# UNITED STATES PATENT AND TRADEMARK OFFICE

APPLICATION NO.	FILING DATE	FIRST NAMED INVENTOR	ATTORNEY DOCKET NO.	CONFIRMATION NO.
10/532,427	04/22/2005	Fujita Kimura	5024-0102PUS1	1679
2292	7590	09/07/2006	EXAMINER	
BIRCH STEWART KOLASCH & BIRCH PO BOX 747 FALLS CHURCH, VA 22040-0747			LANGDON, EVAN H	
			ART UNIT	PAPER NUMBER
			3654

<b>Office Action Summary</b>	<b>Application No.</b>	<b>Applicant(s)</b>	
	10/532,427	KIMURA, FUJITA	
	<b>Examiner</b>	<b>Art Unit</b>	
	Evan H. Langdon	3654

## **DETAILED ACTION**

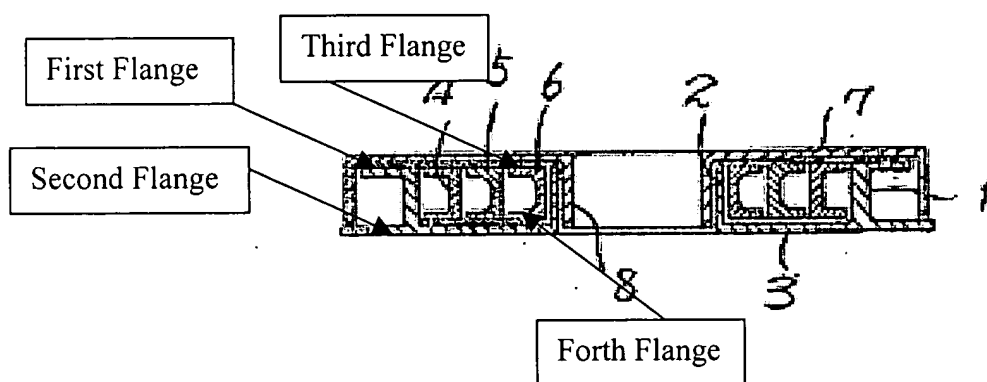
Claim 8 is rejected under 35 U.S.C. 102(b) as being anticipated by JP 30-13286.

JP '286 discloses a spool comprising:

a first spool unit 3 having a first short cylindrical unit 1 around whose outer periphery a fishing line is wound, and a first flange formed on one side of the first short cylindrical unit, and a first side member forming a wall at the other side of the first short cylindrical unit and being used also as a second flange for the other side of the first short cylindrical unit;

a second spool 6 unit having a second short cylindrical unit around whose outer periphery a fishing line is wound, and a third flange formed on one side of the second short cylindrical unit, and a second side member forming a wall at the other side of the second cylindrical unit and being used also as a fourth flange for the other side of the second short cylindrical unit, wherein the second spool unit being disposed inside the first short cylindrical unit in such a fashion that a center of the second short cylindrical unit substantially coincides with a center of the first short cylindrical unit (Fig. 2); and

a support mechanism 2 comprising a support shaft integrally provided at the center of the first side member in a manner that the support shaft is orthogonal to the side member and extends toward the first flange side, and a receiver shaft integrally provided in the second side members which is orthogonal to the side member and extends toward the third flange side to be coupled with the support shaft (see below).

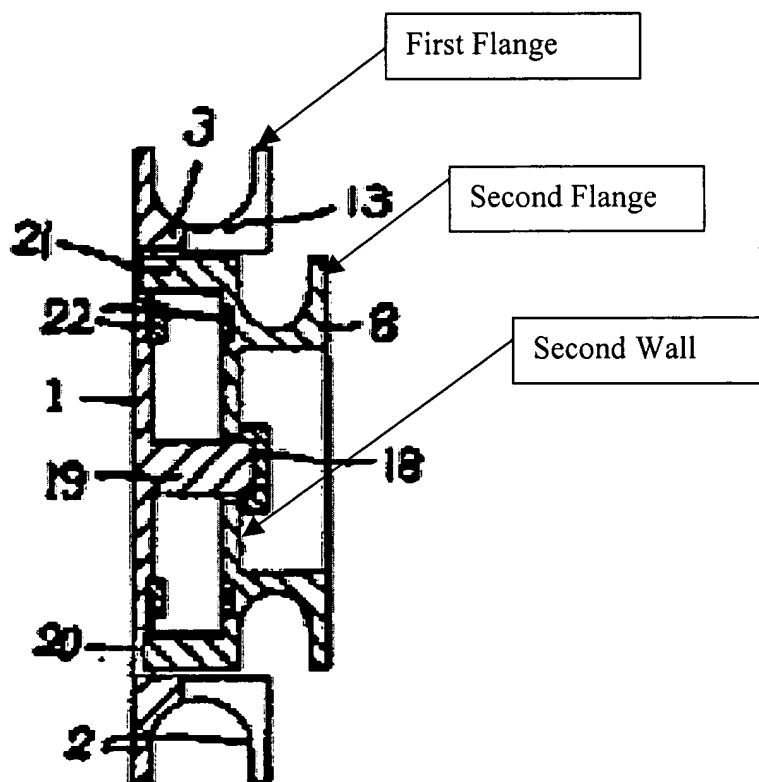
Claims 8, 22 and 25-27 are rejected under 35 U.S.C. 102(b) as being anticipated by JP 4-103473.

JP '473 discloses a spool comprising:

a first spool unit 2 having a first short cylindrical unit 3 around whose outer periphery a fishing line is wound, and a first flange formed on one side of the first short cylindrical unit, and a first side 1 member forming a wall at the other side of the first short cylindrical unit and being used also as a second flange for the other side of the first short cylindrical unit;

a second spool 8 unit having a second short cylindrical unit around whose outer periphery a fishing line is wound, and a third flange formed on one side of the second short cylindrical unit, and a second side member forming a wall at the other side of the second cylindrical unit and being used also as a fourth flange for the other side of the second short

cylindrical unit, wherein the second spool unit being disposed inside the first short cylindrical unit in such a fashion that a center of the second short cylindrical unit substantially coincides with a center of the first short cylindrical unit (Figures 6-8); and

a support mechanism 19 comprising a support shaft integrally provided at the center of the first side member in a manner that the support shaft is orthogonal to the side member and extends toward the first flange side, and a receiver shaft integrally provided in the second side members which is orthogonal to the side member and extends toward the third flange side to be coupled with the support shaft (see below).
